PLANNING COMMISSION REGULAR MEETING AGENDA

Wednesday, May 27, 2026
7 p.m.

5. **P26-0360 and PUD-152, 231 Old Bernal Avenue**- Applications for: (1) Planned Unit Development (PUD) Rezoning (P26-0360) to rezone the subject parcel from MU-T (Mixed Use-Transitional) District to PUD-MU-T (Planned Unit Development-Mixed Use-Transitional) District; (2) Certificate of Appropriateness to demolish an existing 6,160-square-foot commercial office building in the Downtown Revitalization District; and (3) PUD Development Plan (PUD-152) to construct a three-story, four-unit residential building on a 0.49-acre lot, with units ranging in size from 430 square feet to 13,626 square feet and associated site improvements located at 231 Old Bernal Avenue (APN: 94-156-21). The project is exempt from the California Environmental Quality Act (CEQA) pursuant to Public Resources Code Section 21080(b)(5) and CEQA Guidelines Section 15270, which statutorily exempt projects that a public agency intends to deny.

C5.1

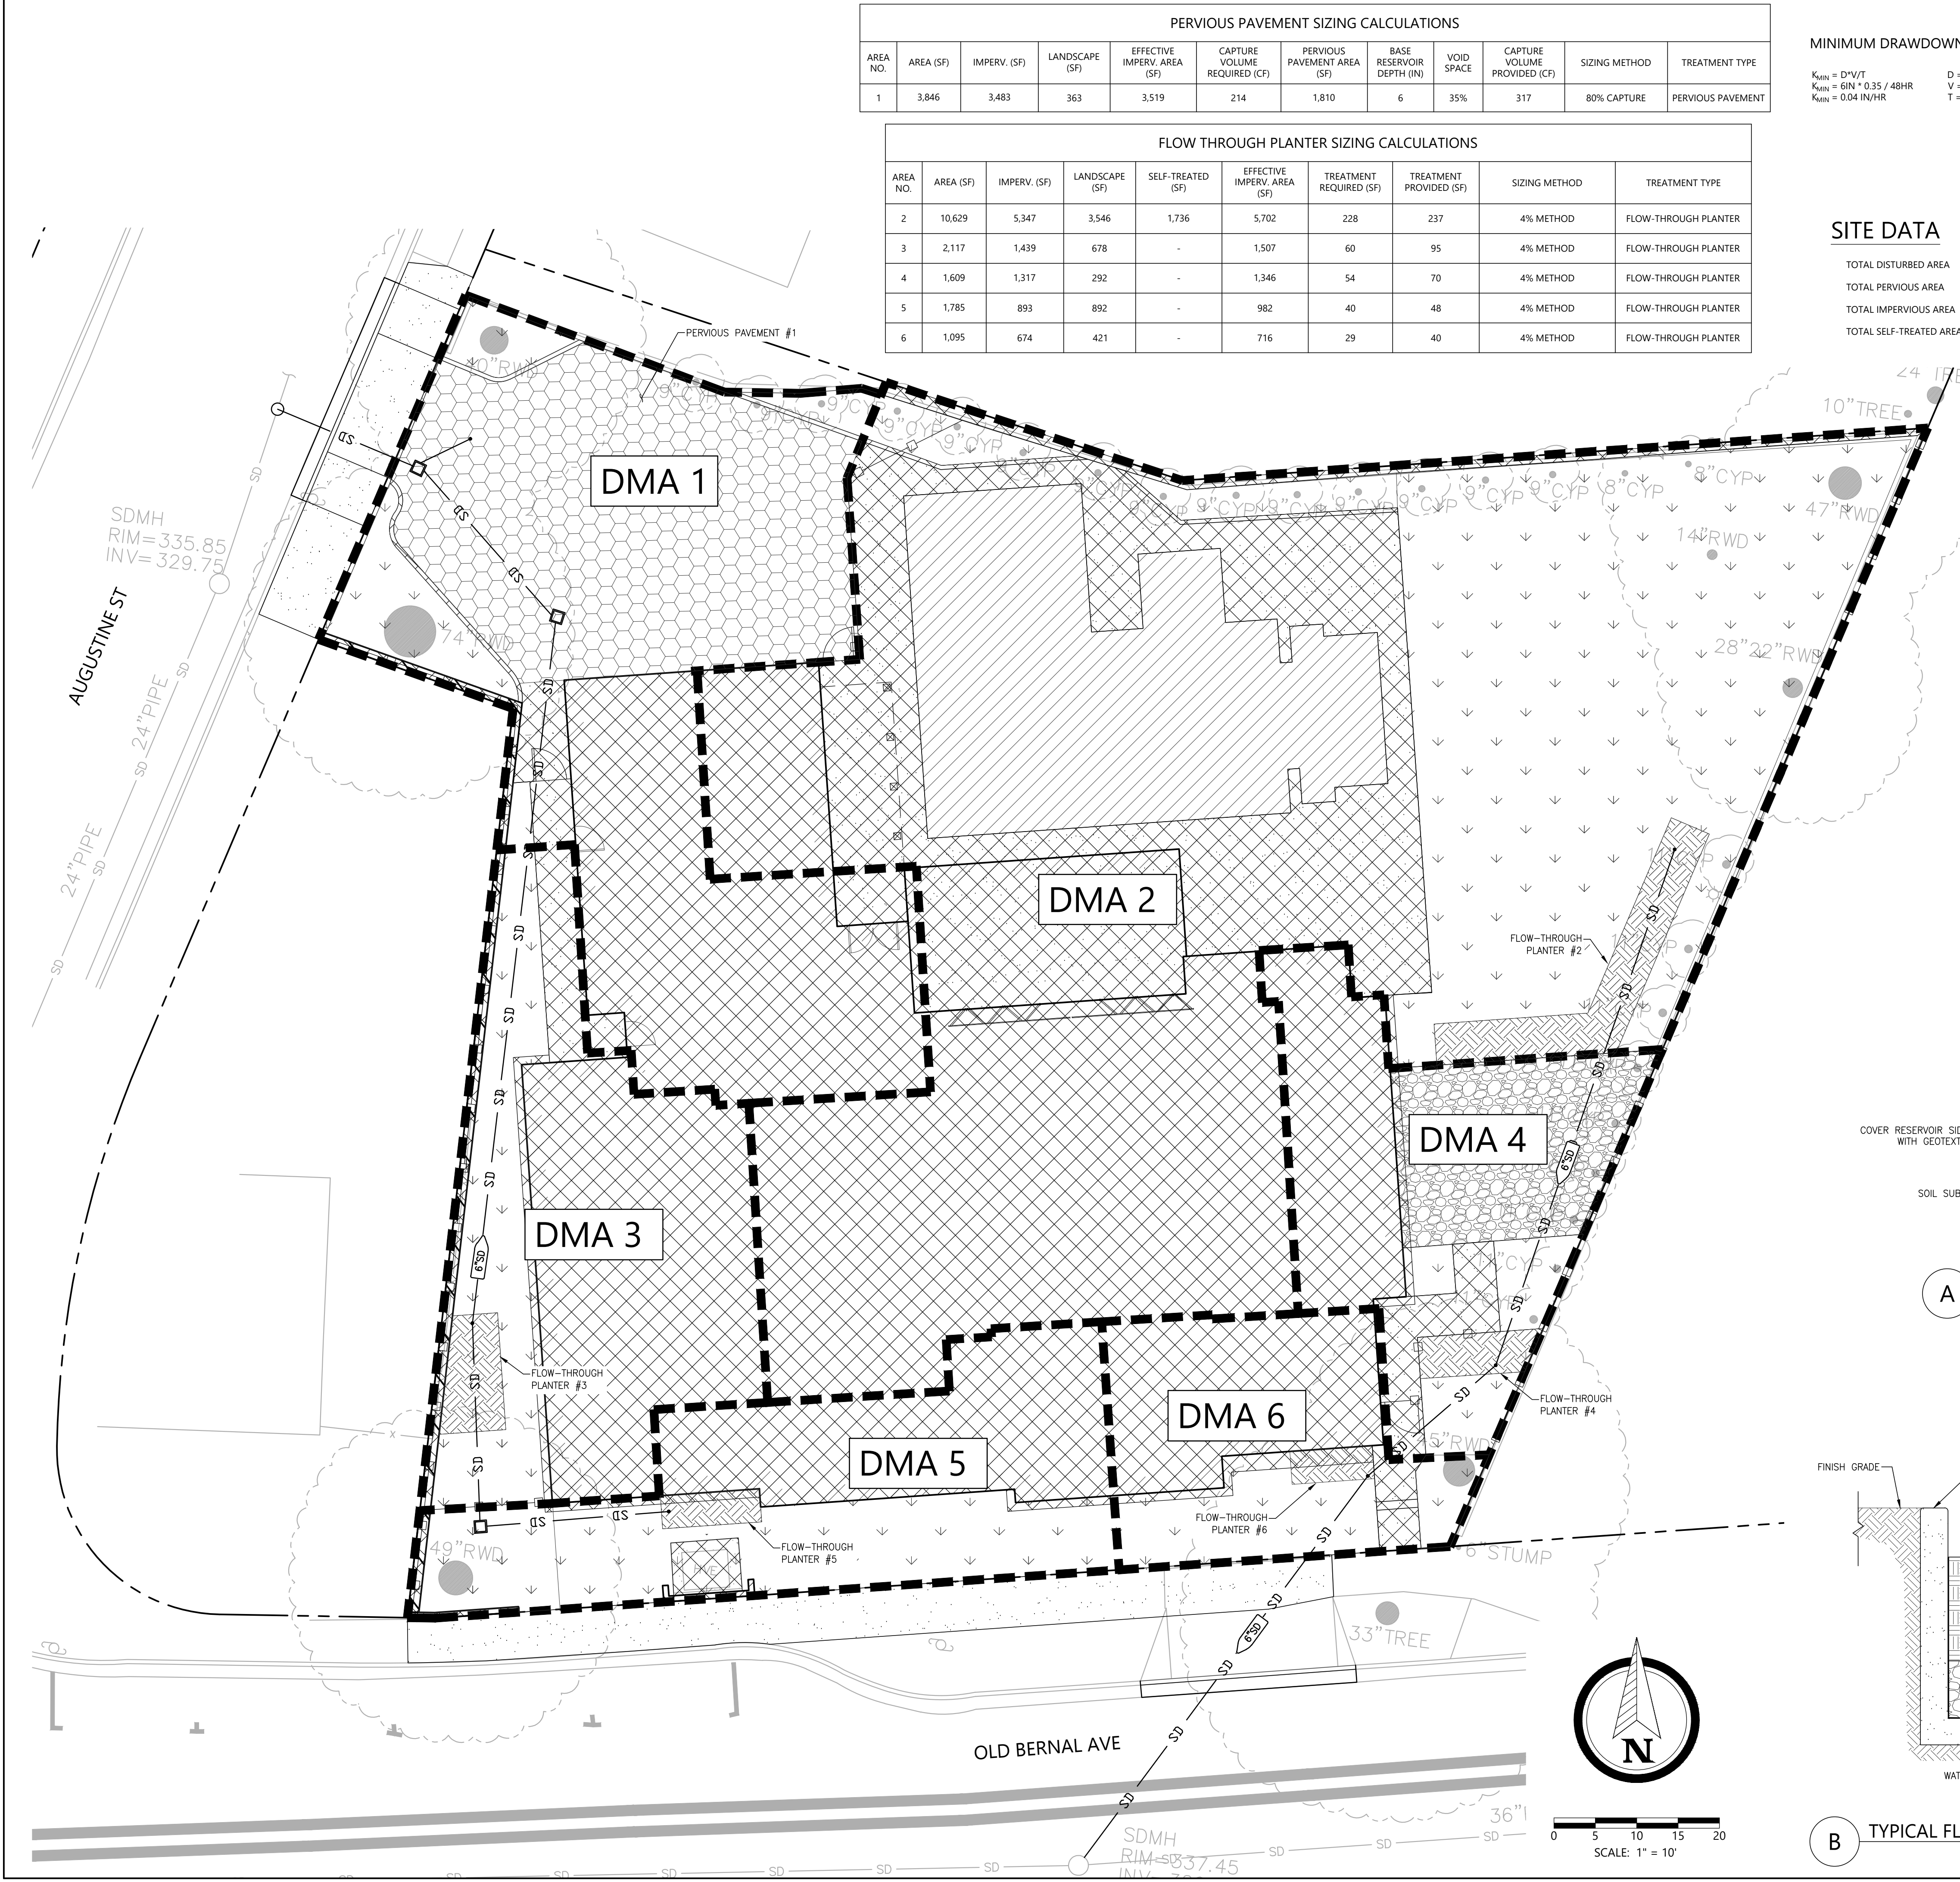
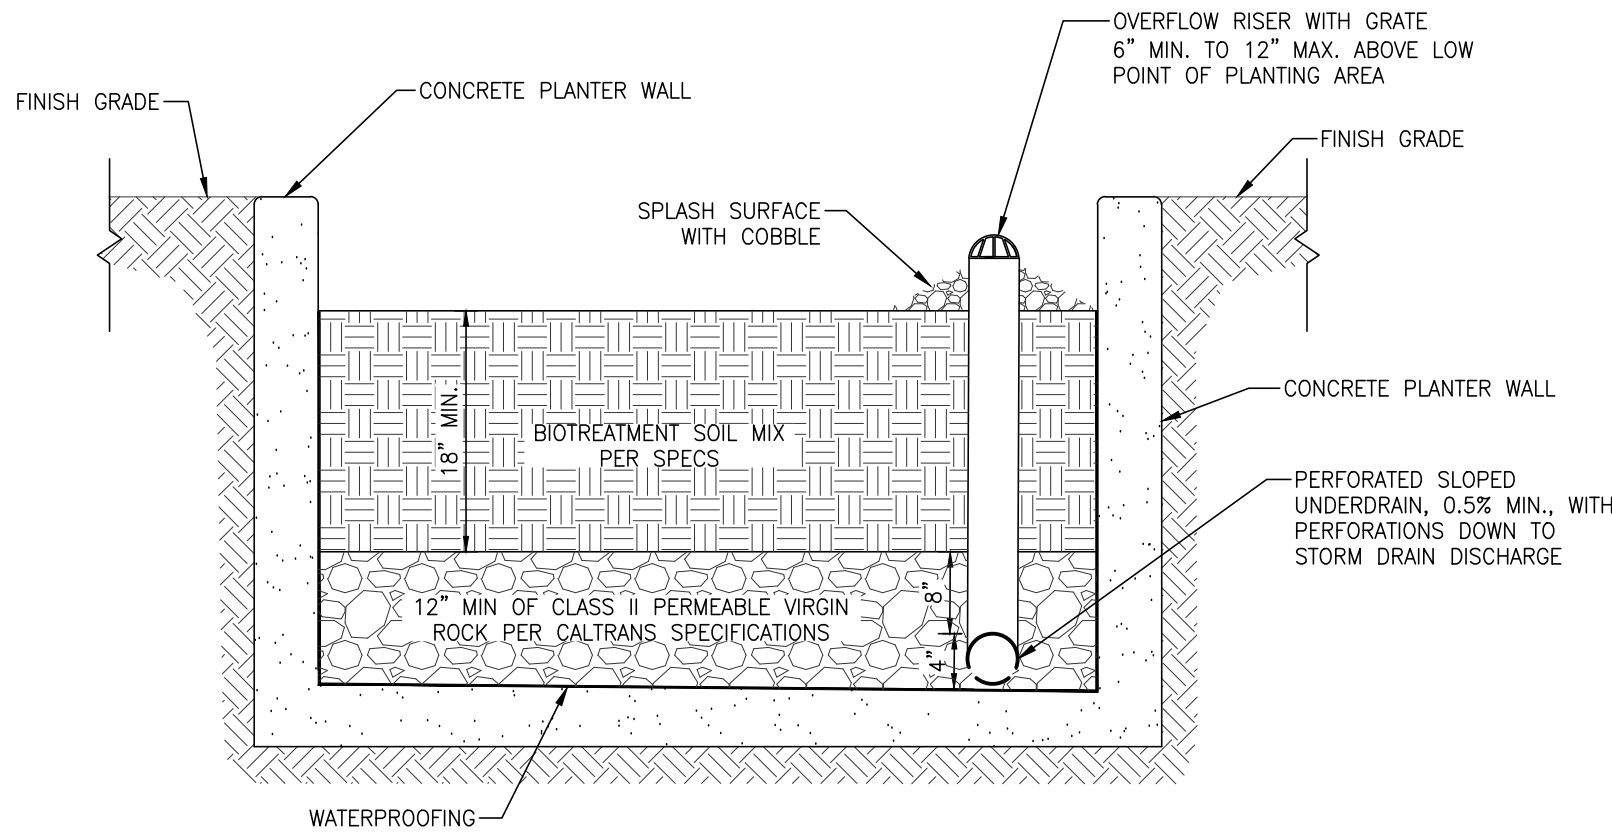
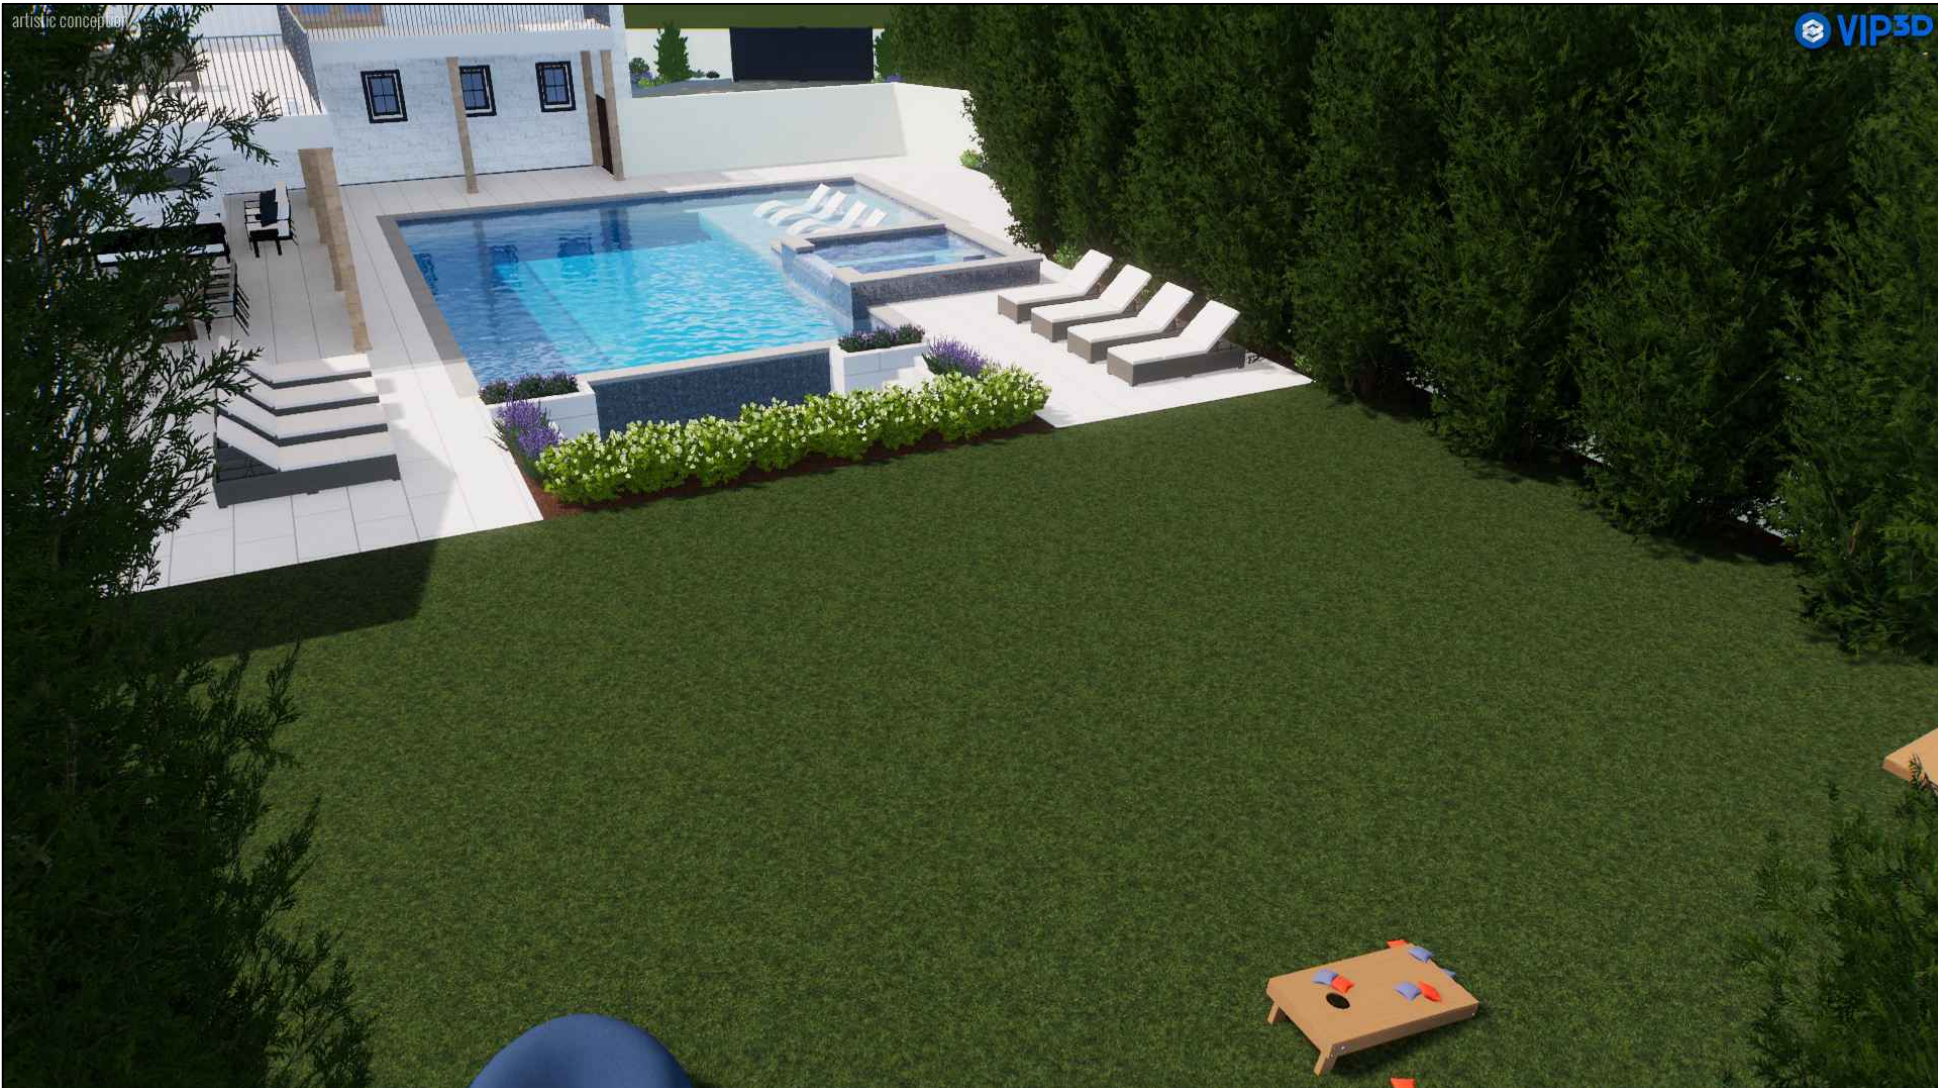
- a. RESOLVED.
- b. RESOLVED.
- c. RESOLVED.
- d. **AMENDED COMMENT.** Sheet C5.1 proposes two different types of treatment features (Pervious Pavement and Flow through Planters). The design drawings require additional clarification:

- (1) RESOLVED.
 - (2) **NEW COMMENT.** Figures 8-11 through 8-13 of the manual shows typical Flow Through Planter design details. Sheet C5.1 provides a typical flow-through planter section within Detail B as an at grade planter.

- (3) RESOLVED.
 - (4) **NEW COMMENT.** Sheet C5.1 shows the swimming pool as a self treating area within DMA #2. Swimming pools are considered an impervious surface and shall

- a) **RESOLVED.**
 - b) **AMENDED COMMENT.** Provide a section detail for permeable pavers (see comment 2c). The revised plan shows section detail with a slurry cap over a sanitary sewer lateral on Sheet C5.1 detail A. Confirm that this cap is intended for the entire length of any sewer laterals.
